1978 Corvette: Service Bulletin: Air Conditioning Compressor Noise

Model and Year: 1978 Corvette with RPO L48 Engine and M38 Automatic Transmission

Bulletin No: 78-T-76

Date: February 1979

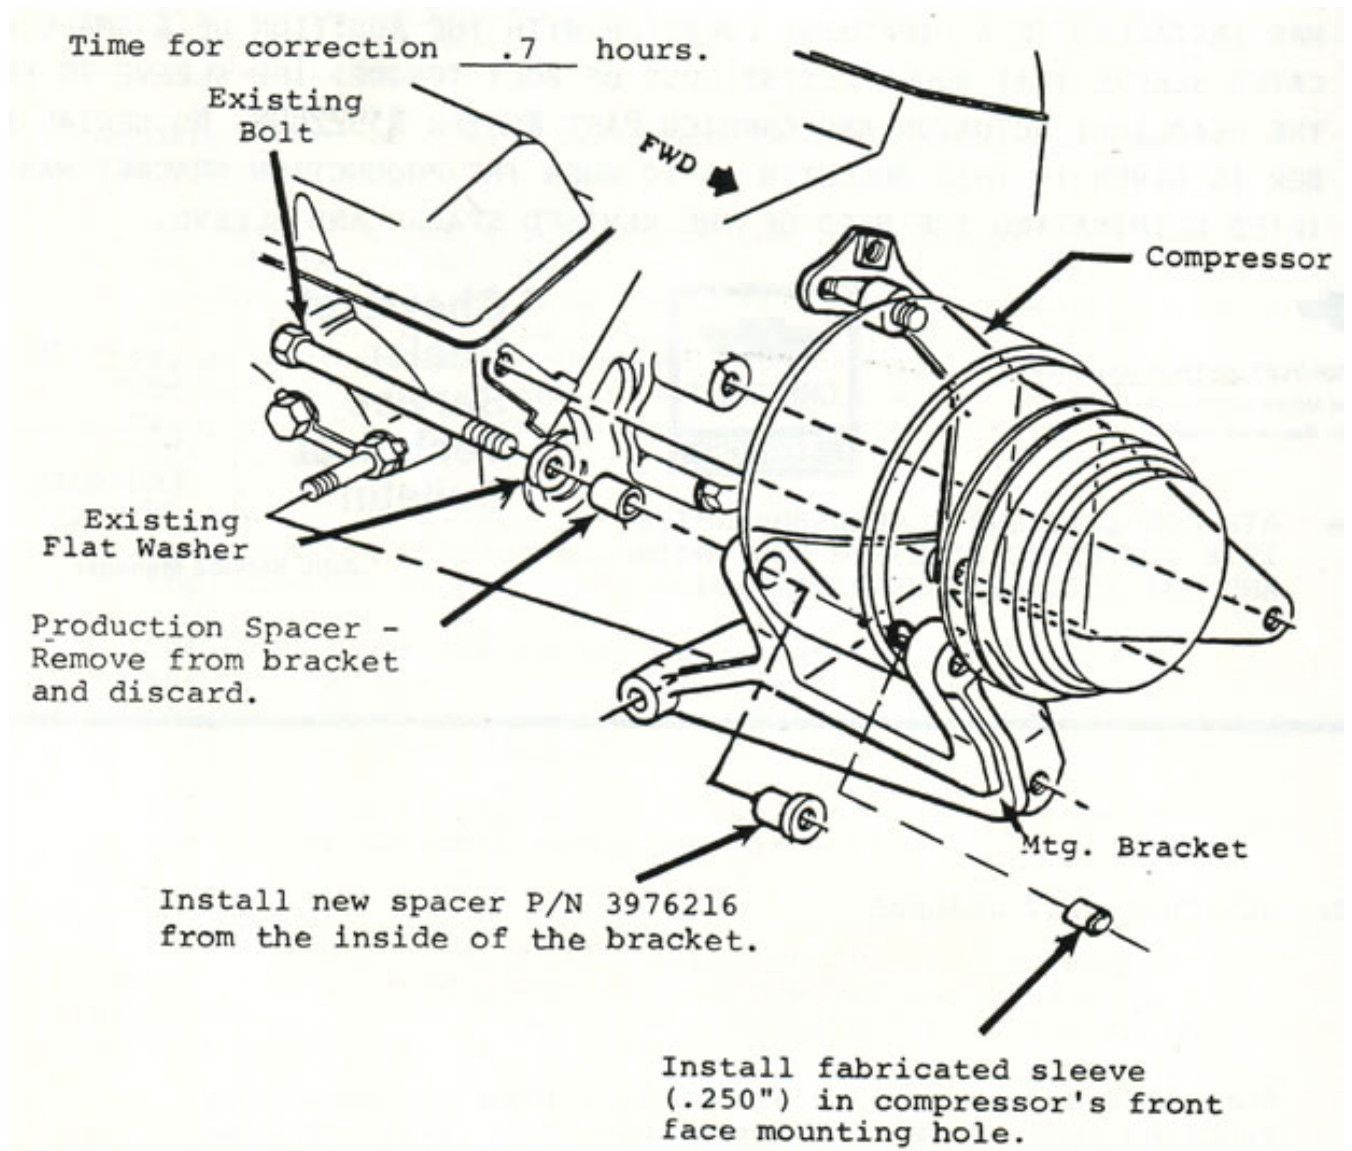
Some 1978 Corvettes with air conditioning may exhibit a rumbling type noise most noticeable at or just off idle RPM, with the air conditioning on, and the transmission in drive.

This condition usually occurs under high ambient temperatures and high head pressured and is caused by a reduction of compressor mounting bolt torque which results in compressor "wobble" and subsequent abnormal deflection of the compressor belt.

In production, the compressor mounting has been revised for 1979 Corvettes. Complaint vehicles can be corrected by using a new mounting bracket spacer, P/N 3976216, and the addition of a sleeve fabricated from a Corvette headlamp actuator sleeve, P/N 3922498, as outlined on page 2.

1. Obtain P/N 3976216 spacer and P/N 3922498 sleeve from stock.

2. Cut the P/N 3922498 plastic sleeve in half, resulting in two .250" long sleeves of which one will be used.
3. Remove the compressor belt and disassemble the compressor from the mounting brackets.
4. Lift compressor from bracket to allow access to both the original spacer in the mounting bracket hole and the mounting hole in the front face of the compressor where the feed-through bolt will exit.
5. Remove original spacer and install new spacer, P/N 3976216 in its place and the fabricated sleeve (.250") in the compressor face mounting hole as shown in Figure 1.
6. Reinstall compressor and belt.
7. Finalize the repair by tightening the compressor belt to 100 +/- 5 lbs. and torquing the compressor mounting bolts to 30 ft. lbs.
